ADDENDUM NO. 2

March 18, 2025

Improvements to Fire Station 4 109 Forest Hills Rd NW, Wilson NC 27893

P-1

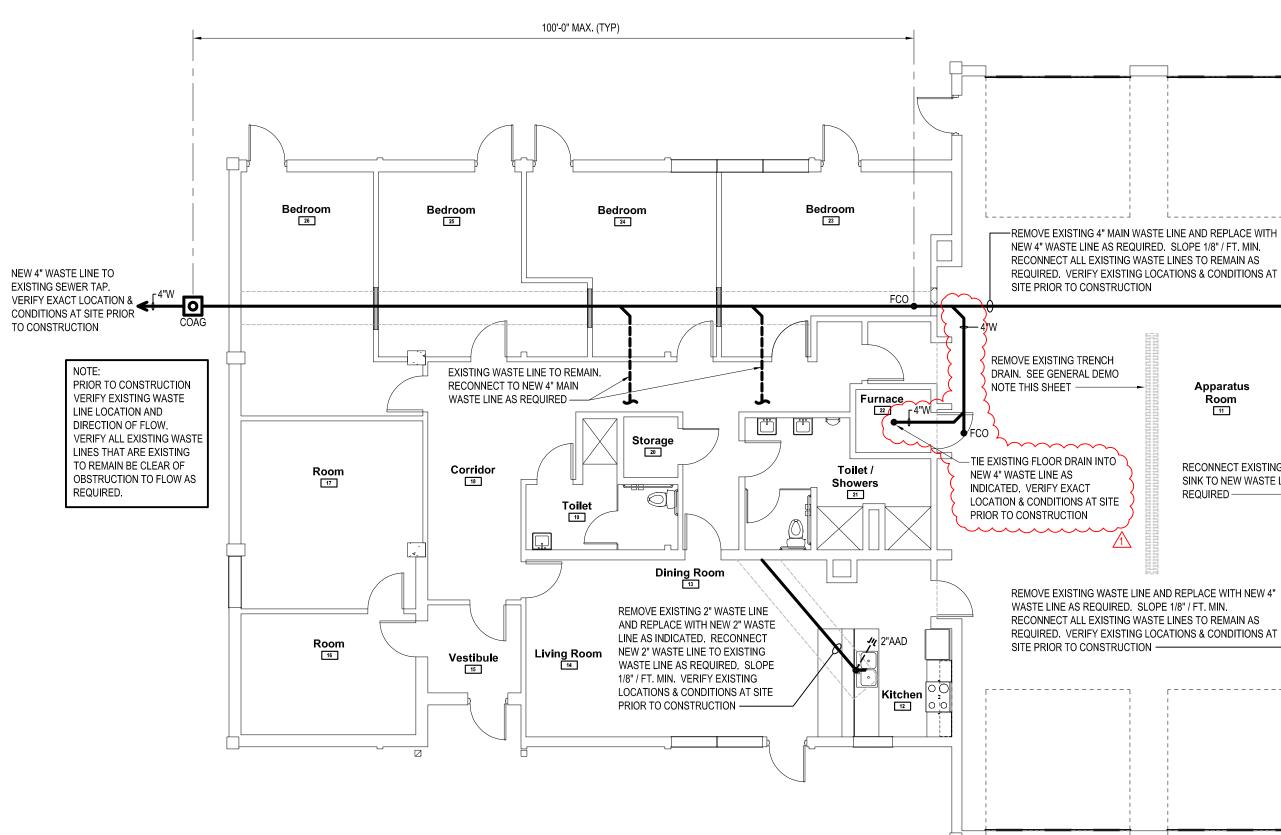
- TRENCH DRAIN OMITTED
